ROCKY VIEW COUNTY

BYLAW C-8193-2021

A bylaw of Rocky View County, to amend the South Conrich Conceptual Scheme Bylaw C-6401-2006.

SCHEDULE 'A'
FORMING PART OF BYLAW C-6401-2006

~~Figure 8 – Conceptual Land Use Plan~~

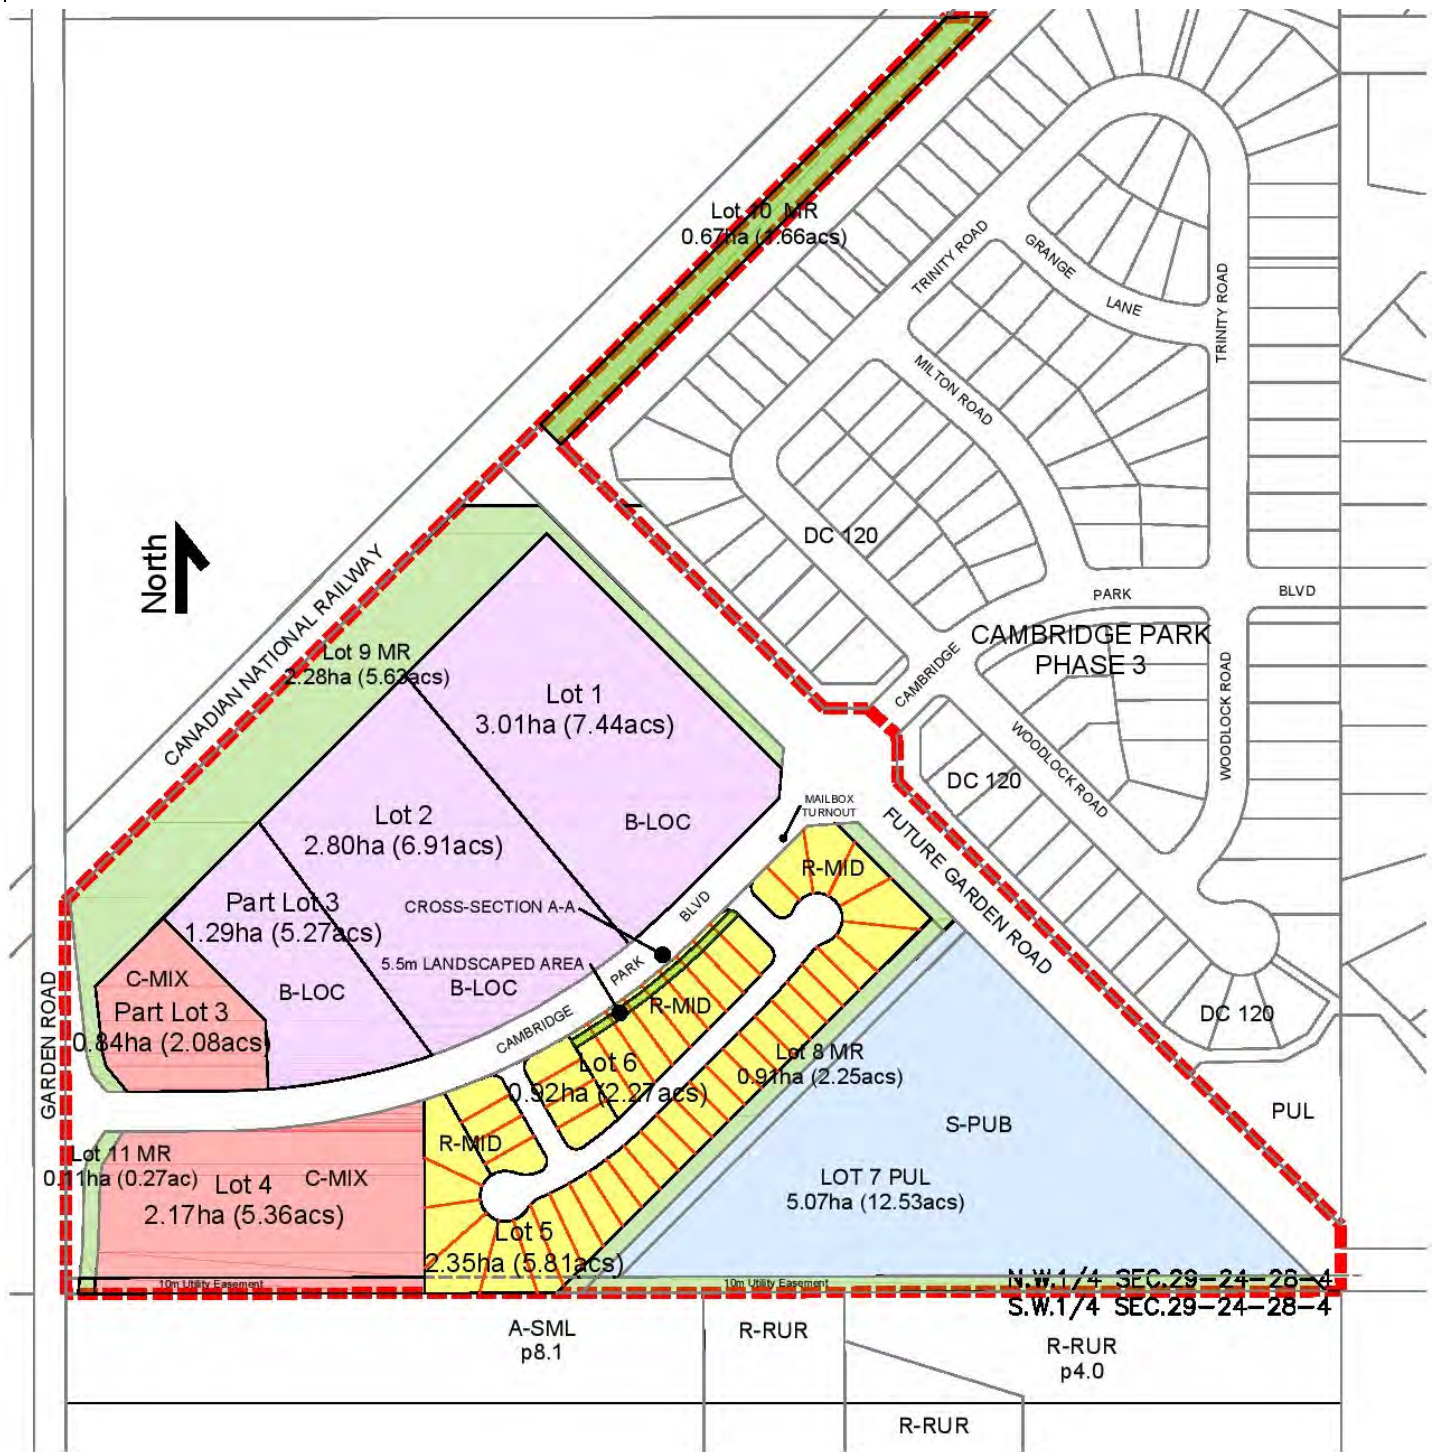
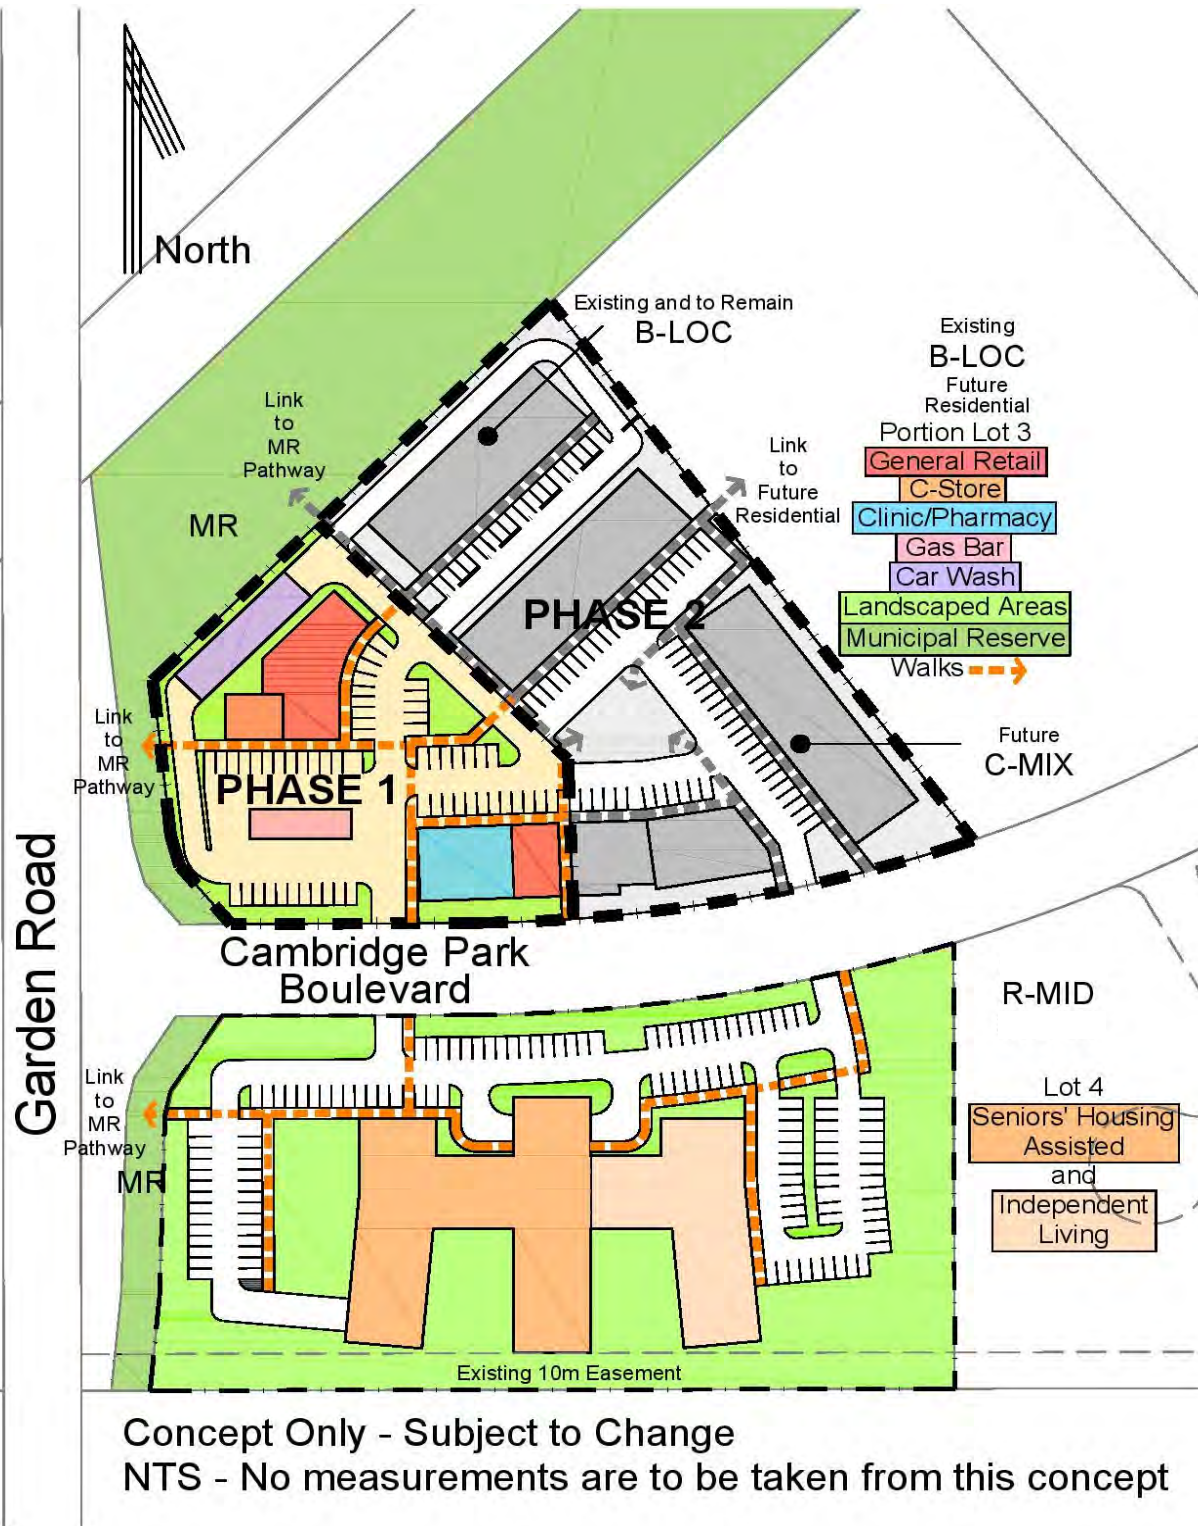
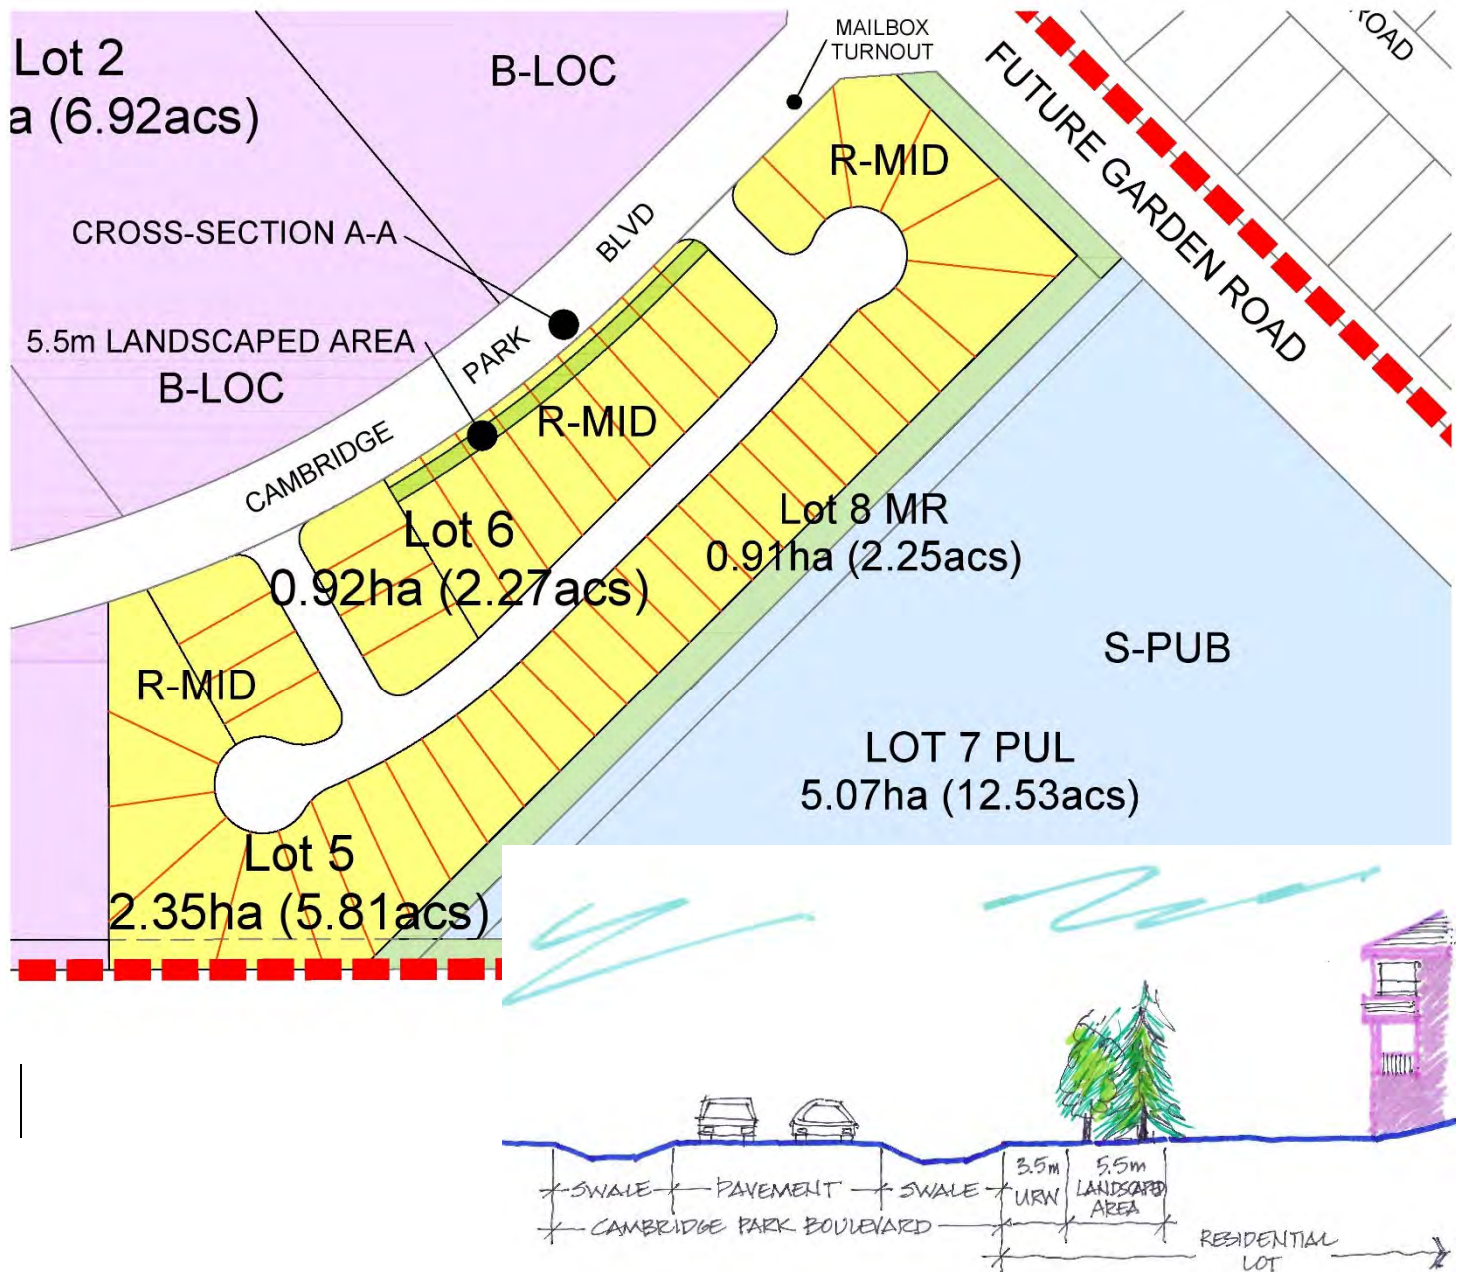
~~A portion of the residential area lies adjacent to Cambridge Park Boulevard. There is an opportunity here to provide some additional landscaping (native trees and shrubs), to serve as a buffer between these residential lots and the future business campus lands to the north. Figure 10—Landscaped Area Plan identifies this augmentation.~~

~~7.0.4 A landscaped area of a minimum 5.5 Metres (18 Feet) shall be provided on lots as identified in Figure 9 – Landscaped Area Plan. The vegetation shall contain mainly large caliper trees but may also contain shrubs. Native species are preferred~~

Figure xx: Cell D Concept Plan

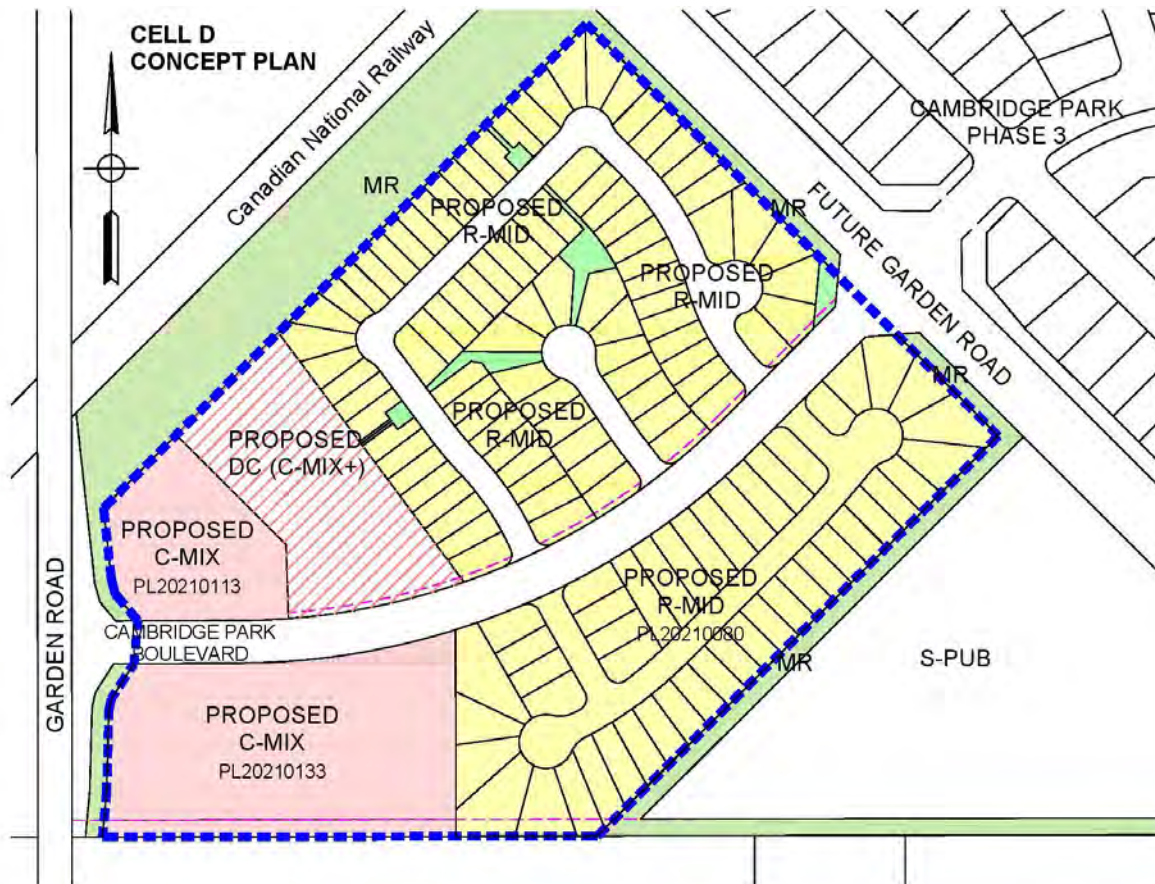
Figure xx: Cell D Concept Plan illustrates the developer's intent for all lands within Cell D. The intent of this figure is to provide certainty to the public that any future development plans will align to this figure. Above all, residential and/or open space uses are intended to be developed adjacent to Cambridge Park Phase 3 / Future Garden Road.

Policy 7.xxxx Any future Cell D applications made to Rocky View County shall generally comply with Figure xx: Cell D Concept Plan
